Project	<b>IEEE 802.16 Broadband Wireless Access Working Group</b> < <a href="http://ieee802.org/16">http://ieee802.org/16</a> >	
Title	<b>Text for Resolution of Session 18 Comments #777, #897, #898, #916</b>	
Date Submitted	<b>2002-03-18</b>	
Source(s)	Robert Nelson Raze Technologies 2540 E Plano Pkwy, Suite 188 Plano, TX 75074	Voice: 972-516-1283 Fax: 972-578-9081 <a href="mailto:bnelson@razetechnologies.com">mailto:bnelson@razetechnologies.com</a>
Re:	Session 18 Comment Resolution.	
Abstract	At session 18, the author was charged by the TGa MAC group to provide text for inclusion in IEEE P802.16a/D3-2002 to resolve comments #777, #897, #898, #916 . This document contains that text.	
Purpose	Text for inclusion in IEEE P802.16a/D3-2002.	
Notice	This document has been prepared to assist IEEE 802.16. It is offered as a basis for discussion and is not binding on the contributing individual(s) or organization(s). The material in this document is subject to change in form and content after further study. The contributor(s) reserve(s) the right to add, amend or withdraw material contained herein.

## Text for Session 18 Comment Resolution

Figure 6.xxx -ARQ Reset Message Dialog—Transmitter Initiated

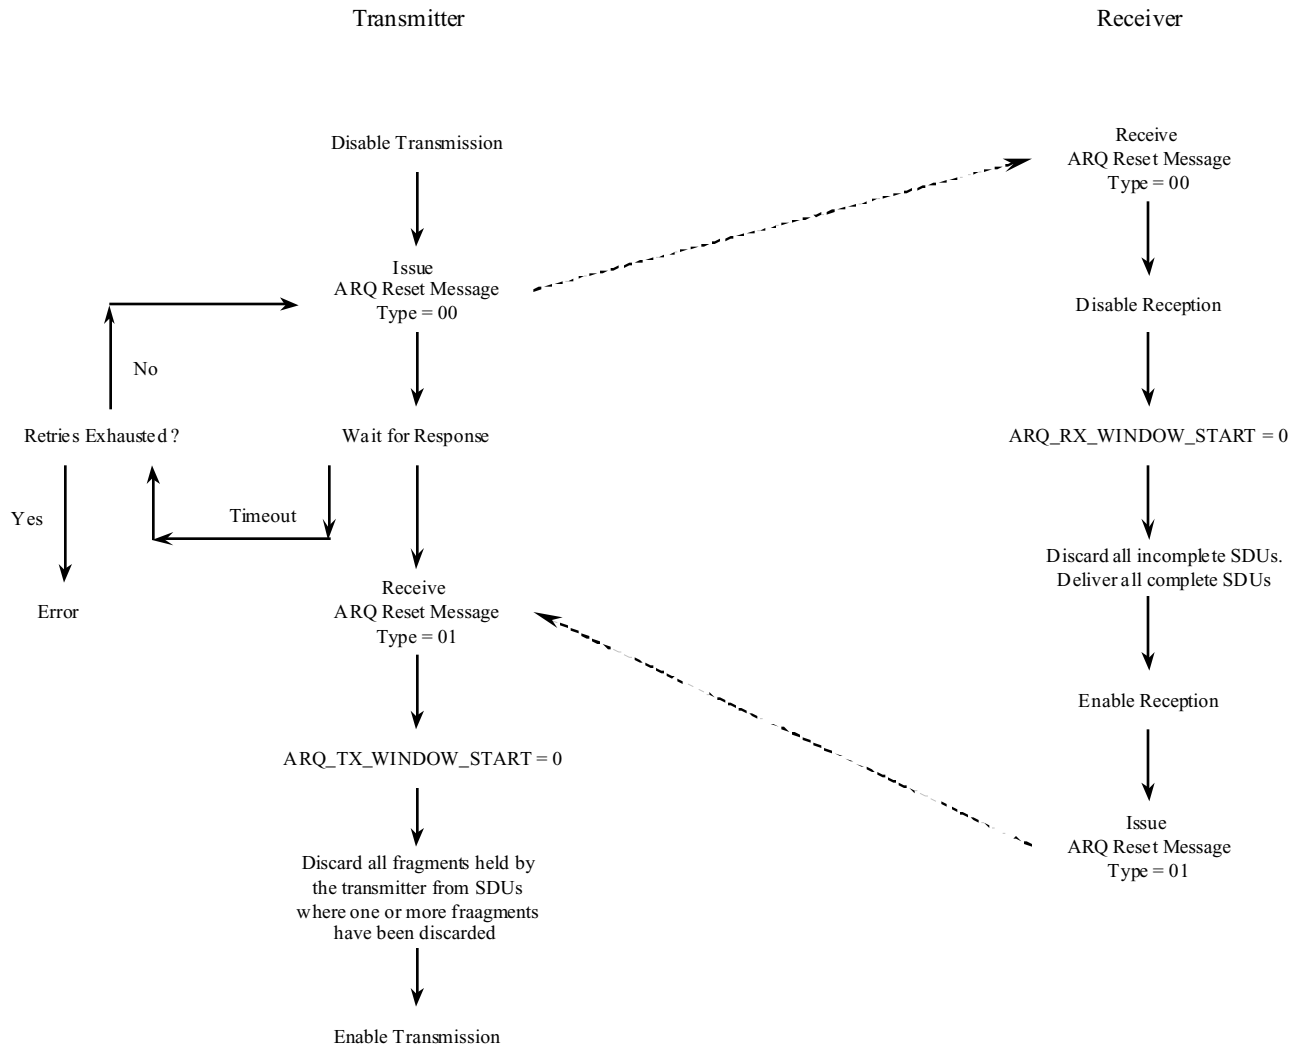
*Insert the figures on the following pages at a “convenient” location near the above text references (they were built and can be edited with Word PowerPoint editor):*

The actions to be taken by the transmitter state machine when an ARQ Reset Message is received are provided in Figure 6.xx, ARQ Reset Message Dialog – Receiver Initiated. The actions to be taken by the transmitter state machine when it wants to initiate a reset of the receiver ARQ state machine are provided in Figure 6.xx, ARQ Reset Message Dialog – Transmitter Initiated.

The actions to be taken by the receiver state machine when an ARQ Reset Message is received are provided in Figure 6.xx, ARQ Reset Message Dialog – Transmitter Initiated. The actions to be taken by the receiver state machine when it wants to initiate a reset of the transmitter ARQ state machine are provided in Figure 6.xx, ARQ Reset Message Dialog – Receiver Initiated.
